**BEFORE THE PUBLIC UTILITIES COMMISSION  
OF THE STATE OF SOUTH DAKOTA**

**IN THE MATTER OF THE  
APPLICATION OF DEUEL HARVEST  
WIND ENERGY LLC FOR A PERMIT  
OF A WIND ENERGY FACILITY AND  
A 345-KV TRANSMISSION LINE IN  
DEUEL COUNTY**

**APPLICANT'S RESPONSES TO  
STAFF'S FOURTH SET OF DATA  
REQUESTS TO APPLICANT**

**APPLICANT’S RESPONSES TO  
STAFF’S FIFTH SET OF DATA  
REQUESTS TO APPLICANT**

Figure A-2 Turbine 1  
Turbine Siting Constraints Map  
Deuel Harvest North Wind Farm  
Deuel Harvest Wind Energy LLC  
Deuel County, South Dakota

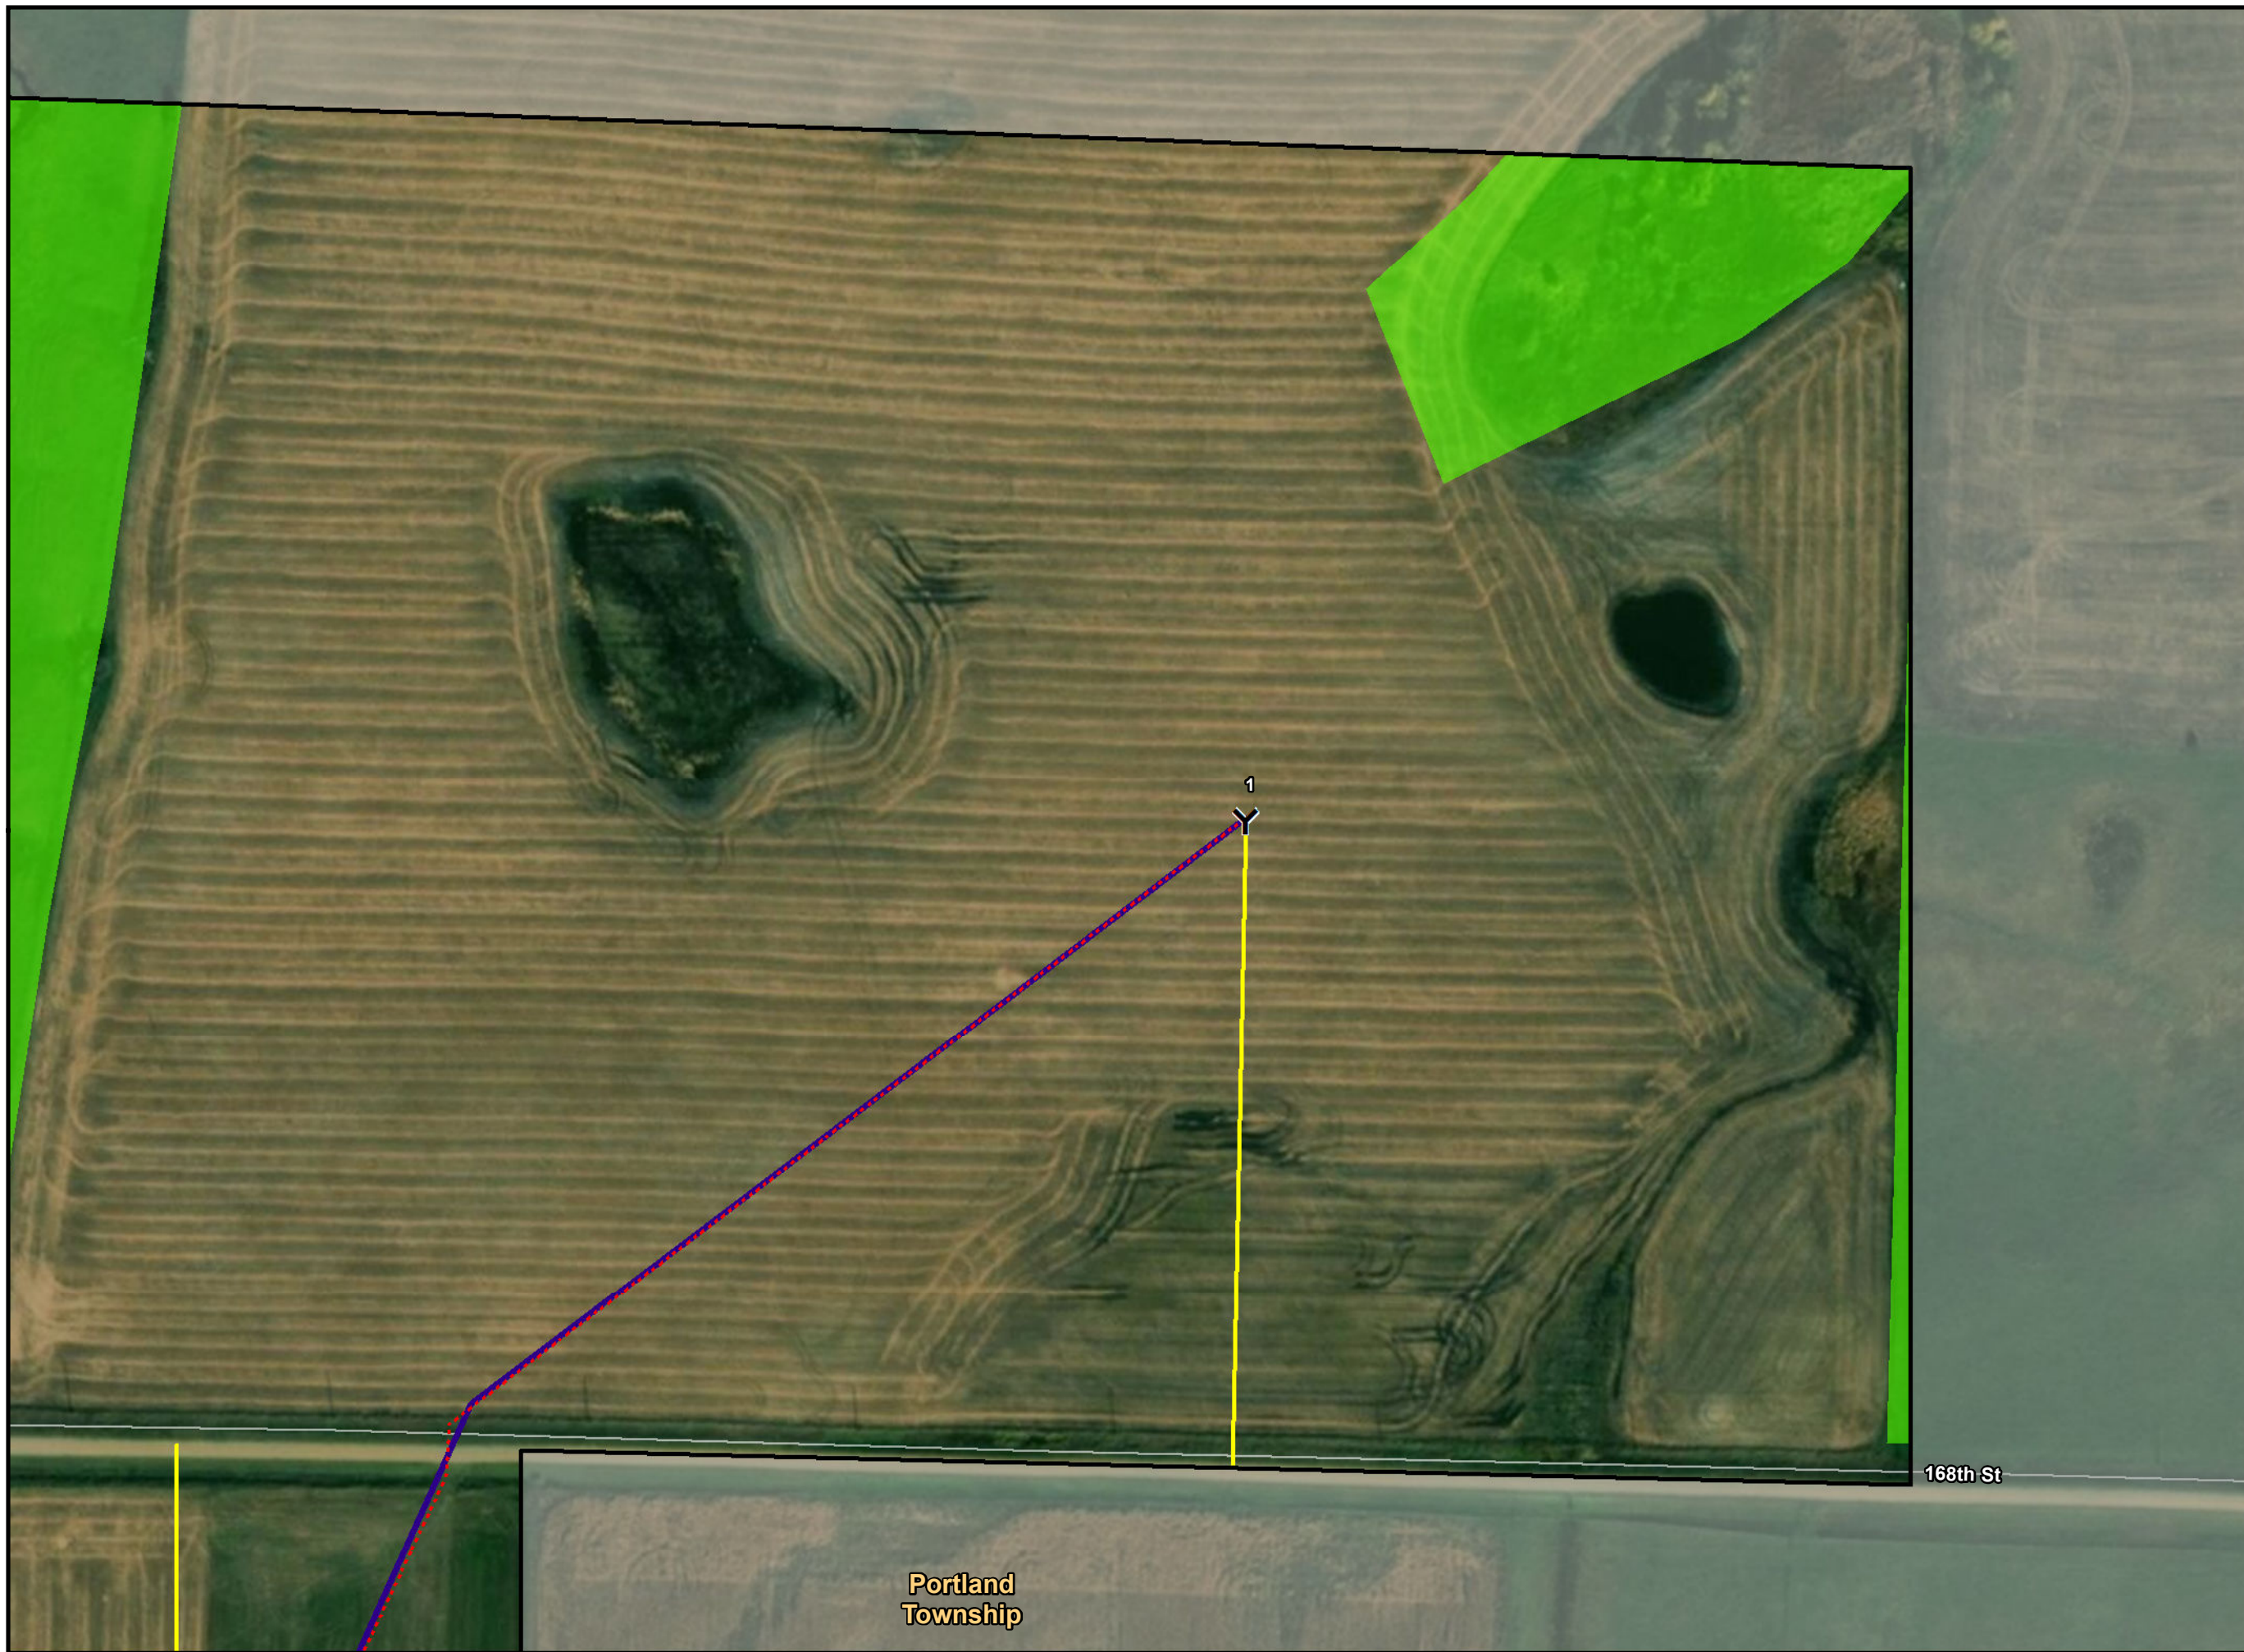
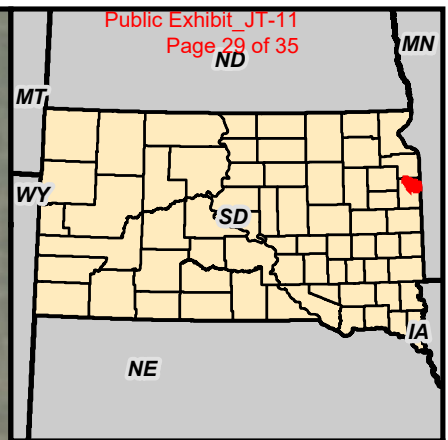
**6-6) Refer to Deuel Harvest's response to Commission Staff data request 5-13)b) and Appendix A, Figure 2 – Turbine Siting Constraints Map.**

- a) Please provide a turbine constraints map specifically for Turbine 1, simply zooming in on Figure 2, but identifying all the constraints Mr. Svedeman stated in response to 5-13)b)II.**

**I. Please explain the value of the turbine constraint map submitted in Figure 2 if a 120 foot turbine move cannot be analyzed with that specific map.**

Michael Svedeman: See Attachment 6-6(a). Note that this figure does not include cultural resources or wetland constraints, as field surveys for those resources have not been conducted in areas where no facilities are currently proposed.

Michael Svedeman: A constraints map identifies constraints known to Deuel Harvest as a result of setbacks, other regulations, and desktop and field survey work. In general, field surveys are completed for where facilities are planned to be located. In the event that facilities are shifted, additional field surveys may be conducted if the new location falls outside the surveyed corridor. The survey corridors for Wetland Delineations and Cultural Resources Surveys included turbine locations (250-foot radius), access roads (100-foot on either side of the centerline), collector lines (50-foot on either side of the centerline), and crane paths (50-foot buffer on either side of the centerline). In other words, a constraints map identifies known, geographically-definable constraints, rather than definitively identifying all areas where facilities could be located.
